## **Appendix B1 – Applicant Response to DPIE Water advice**

**RE: SSD-7171 & SSD-7172 THE HUME COAL MINE AND BERRIMA RAIL PROJECTS  
RESPONSE TO AGENCY COMMENTS – DPIE WATER.**

**Re: Hume Coal response to DPIE-Water memo of July 2020**

Hume Coal and Berrima Rail Project  
Addendum to Updated Noise Assessment  
Figure 3.1

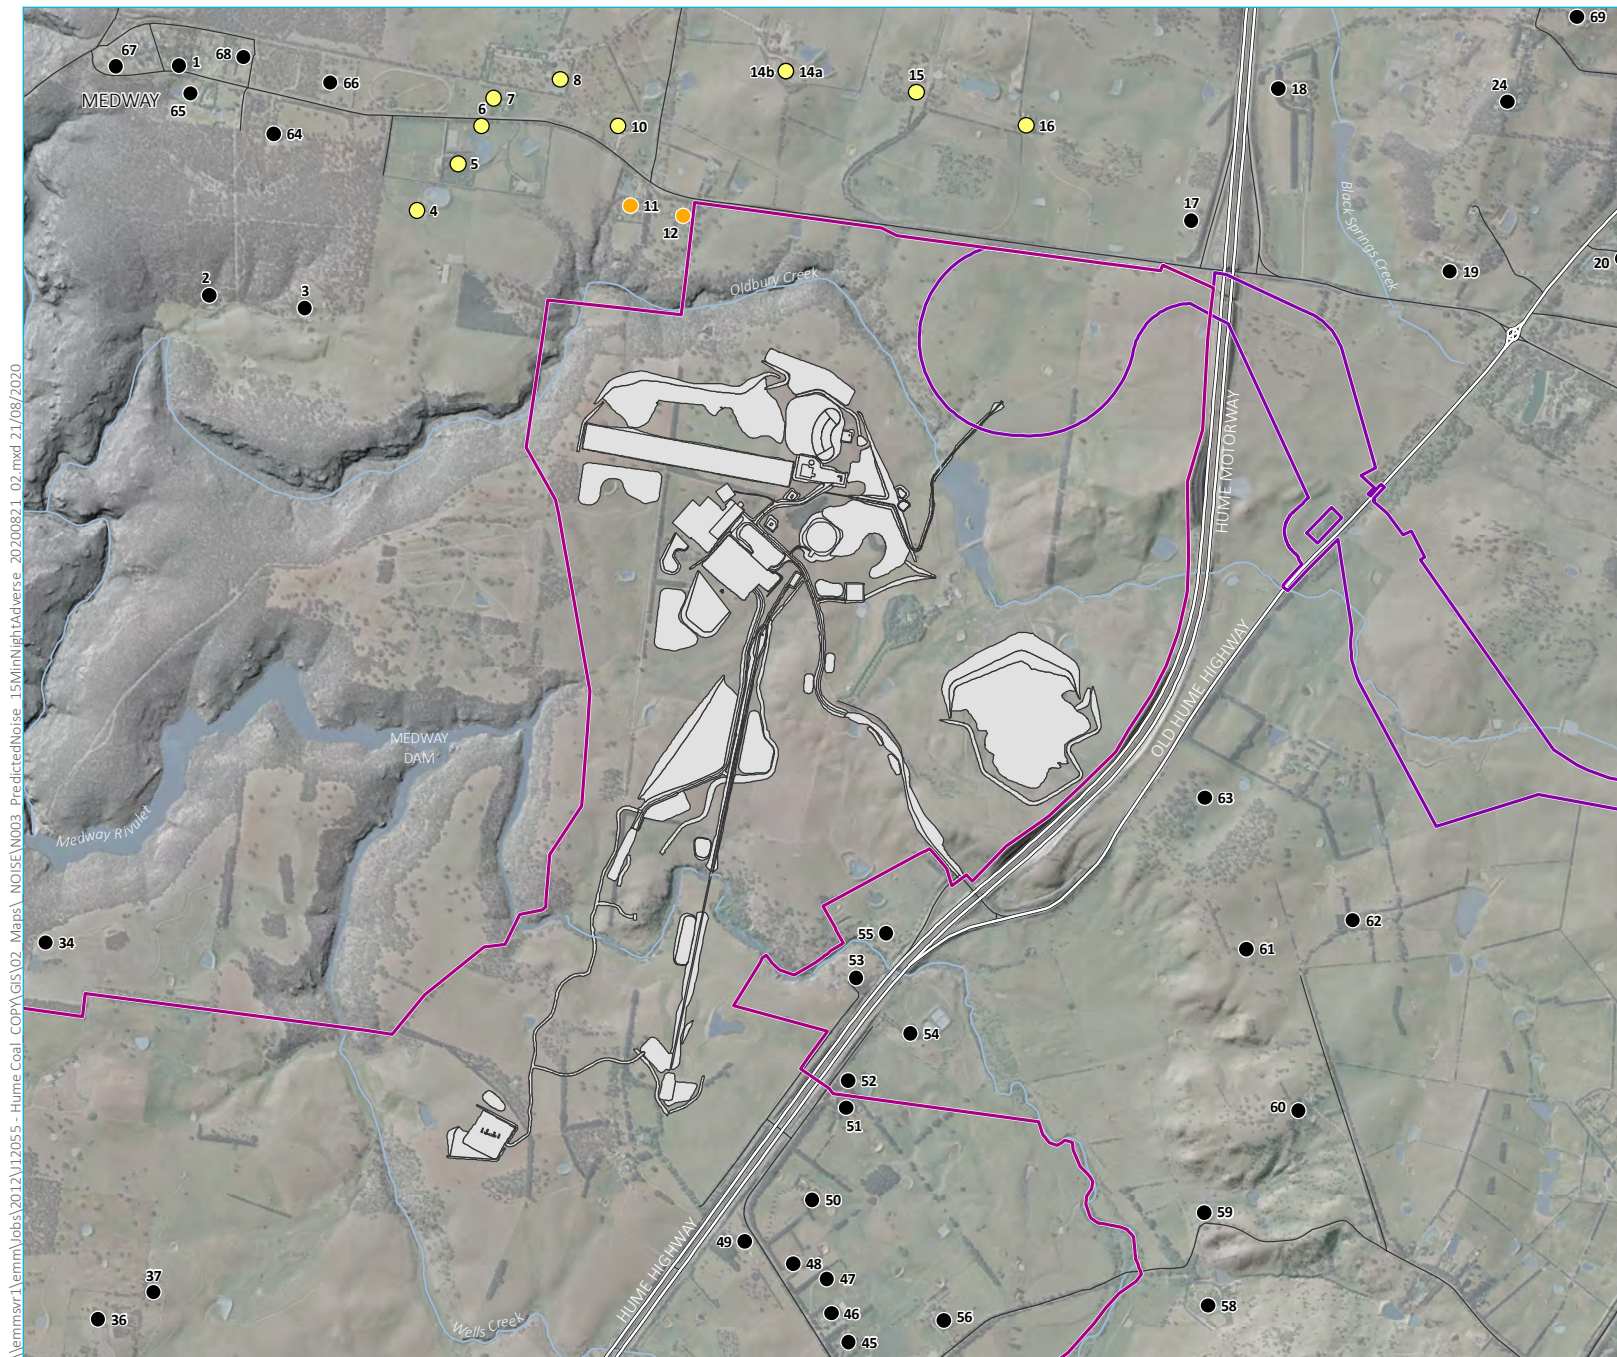
The EPA state “The EPA’s review of the original EIS contains a map of affected receivers (attached below from EIS, Volume 7, Appendix I, Noise and Vibration Assessment Report). The map shows that receiver number 12 and 13 may be significantly affected by noise and are entitled to voluntary acquisition. There is no receiver location 11. However, Figure 14.4 of the Response to Submissions shows receivers locations 10 and 11 but no receiver 13.

Location 10 has been mapped in the EIS and RTS. The application of the NPfI (2017) and VLAMP (2018) has reduced the overall VLAMP characterisation of this location from ‘moderate’ to ‘marginal’, as is the case for Locations 4, 5, 6, 8, 14, 15 and 16. Location 10 is not predicted to exceed the day project noise trigger level (PNTL), as shown to comply on Figure 2.1. However, during the night period the predicted noise levels exceed the PNTL for both the ‘standard’ and ‘adverse’ (noise-enhancing) conditions, respectively categorising Location 10 as ‘negligible’ for standard night conditions (Figure 2.2) and ‘marginal’ for adverse night conditions (Figure 2.3). As mentioned above and in Table 3.1 the overall characterisation of Location 10 under the VLAMP (2018) is ‘marginal’ (Figure 3.1).

Under the application of the NPfl (2017) and VLAMP (2018) the overall VLAMP characterisation of Location 11 is 'significant'. Location 11 is predicted to exceed both day and night PNTLs; and is categorised as 'marginal' for day conditions (Figure 2.1), 'marginal' for standard night conditions (Figure 2.2) and 'significant' for adverse night conditions (Figure 2.3). As mentioned above and in Table 3.1 the overall characterisation of Location 11 under the VLAMP (2018) is 'significant' (Figure 3.1).

Location 12 was mapped in the EIS and RTS. Under the application of the NPfl (2017) and VLAMP (2018) the overall VLAMP characterisation of Location 12 remains 'significant'. Location 12 is predicted to exceed both day and night PNTLs; and is categorised as 'marginal' for day conditions (Figure 2.1), 'marginal' for standard night conditions (Figure 2.2) and 'significant' for adverse night conditions (Figure 2.3). As mentioned above and in Table 3.1 the overall characterisation of Location 12 under the VLAMP (2018) is 'significant' (Figure 3.1).

FIGURE 3.4. Illustration of the Extreme Nature of the Numerical Model Calibration Point by Reference to International Subsidence Behaviour (GAPL 2018)

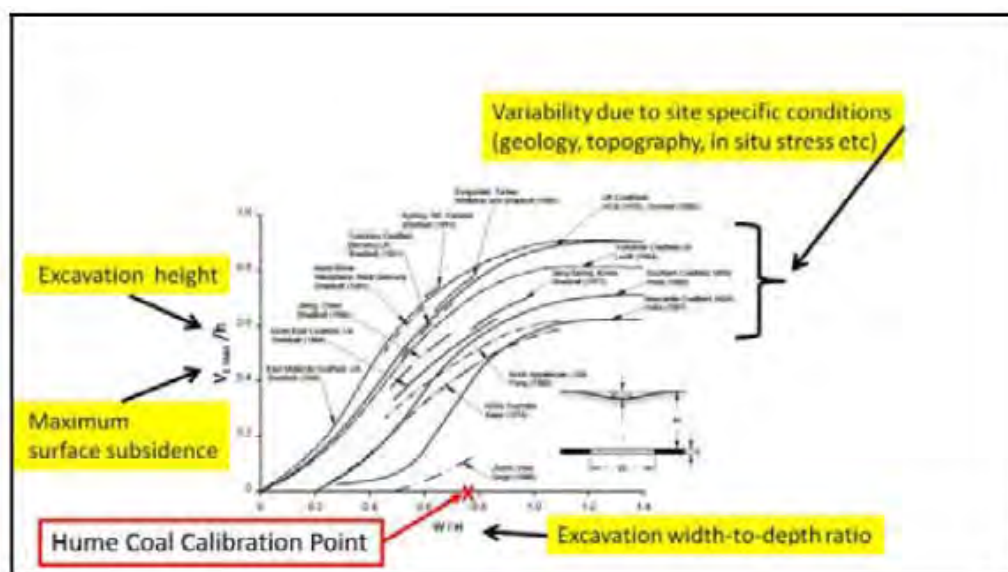
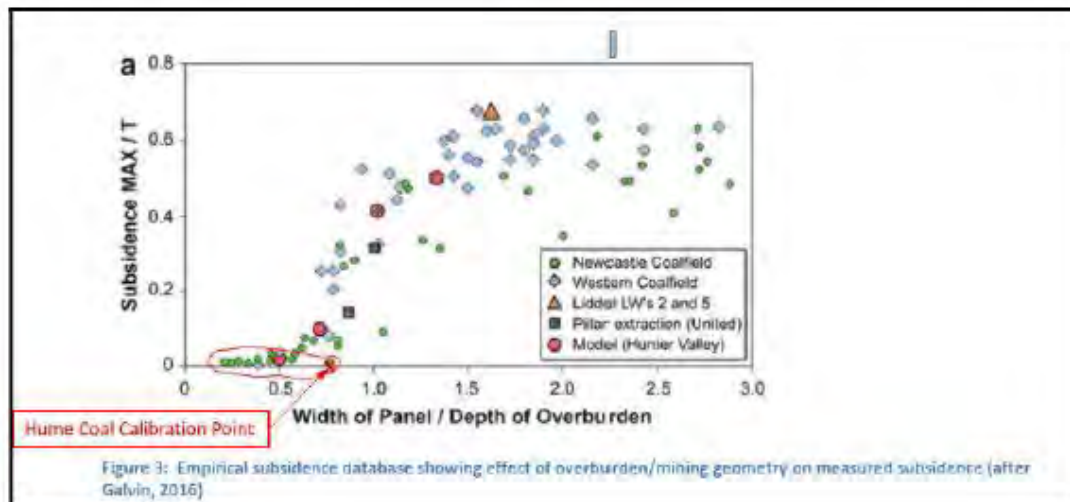
*"The extreme nature of the negligible subsidence is illustrated by reference to Figure 1 and Figure 2 (Figure 2 is incorrectly attributed to Galvin). As another point of reference, GAPL calculated predicted surface subsidence using the methodology and material values presented in the Hume Coal EIS. This approach predicts a surface subsidence of about 130 mm for the given dimensions".*

GAPL 2018 refers to two figures (reproduced herein as Figures 3.4 and 3.5) in explaining the basis of the concern raised. These will be referred to as required in formulating this response.

The first point to make is that the  $S_{\max}$  magnitude that was used in calibrating the overburden in LaModel, was based on three measurements rather than one, such that any subsidence modifying influence at work must have presumably been of similar magnitude in all cases. The three subsidence cross-lines and the underlying mine workings from Berrima are shown in Figure 3.6 and the following comments are made:

If it is accepted for the sake of argument that surface subsidence above SW1 panel is not being significantly influenced by remnant coal in areas of attempted full extraction, the question then remains as to whether there are other reasons as to why the magnitude of  $S_{\max}$  being  $< 10$  mm is extremely low, as compared to comparable extraction panels, this being clearly indicated by the reviewer based on Figures 3.4 and 3.5.
